BREAK SHARP EDGES LESS UNLESS OTHERWISE SPECIFIED DIMENSIONS ARE IN INCHES	125	DESIGNED	T.S.	DATE
		DRAWN	DATE	3/16/95
TOLERANCES ARE: FRACTIONS DEGREES ANGLES +1/8" ±.003 22° XX ±.000 XXX ±.010		CHECKED	DATE	
		APPROVED	DATE	4/3/95
Geneva Aviation www.GenevaAviation.com				
STAINLESS BRACKET				
THIS DOCUMENT INCLUDES INFORMATION PROPRIETARY TO GENEVA AVIATION AND SHALL NOT BE USED OR DUPLICATED BY ANYONE WITHOUT THE WRITTEN PERMISSION OF GENEVA AVIATION, INC.				
Drawing Number G10608		REV B		
Pro No: GA159		SIZE B	Scale: 1:1	Sheet 1 of 1

WRITER TAB	CHECK	APPROVED	QA	PROGRAM GA159	DRAWING NO. G10608	SHT# 1
REASON UNCLEAR AND DOUBLE DIMS	EFFECTIVITY		TITLE		STAINLESS BRACKET

GENEVA AVIATION ADCN

ISOMETRIC VIEW
SCALE: 1/2

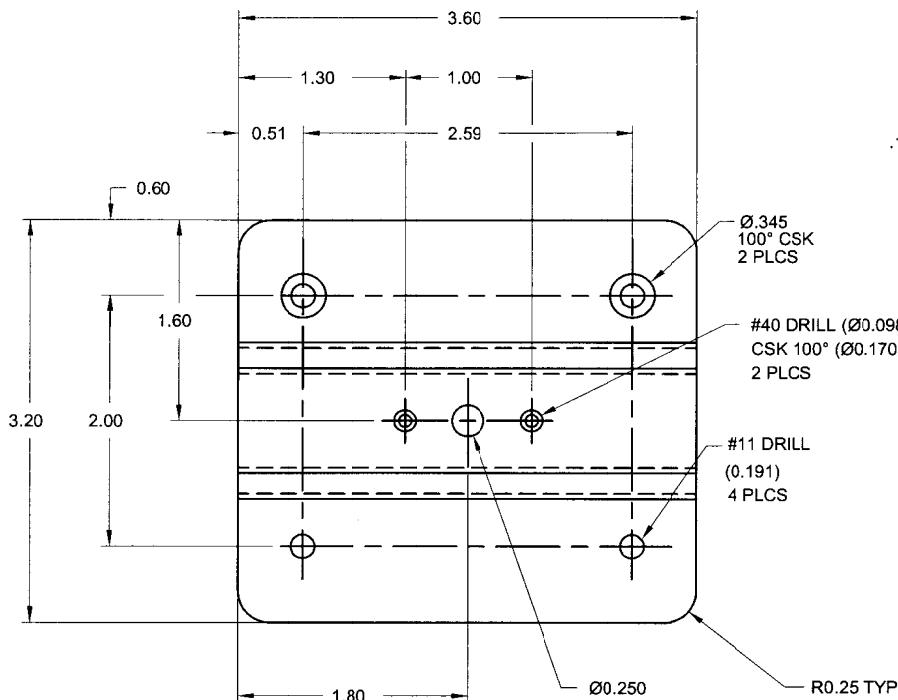
REVISIONS		
REV	DESCRIPTION	APVR DATE
A	-#40 DRILL WAS #30, (.00.170) WAS (.00.240), .00.25 WAS .00.425 -ADDED -2 BUSHING. -RENAME DRAWING TITLE.	6/13/95 GLH
B	-REVISED TOLERANCE ON -2 BUSHING ID HOLE TO $\pm .003$	5/17/04 CLB

* ADCN REF INFORMATION ADCN B1

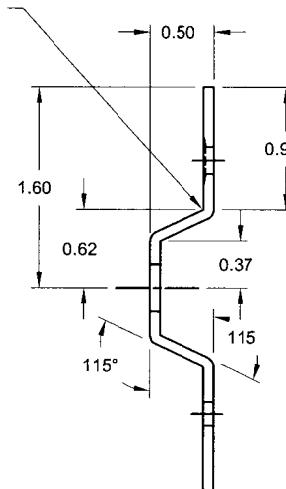
IS

WAS
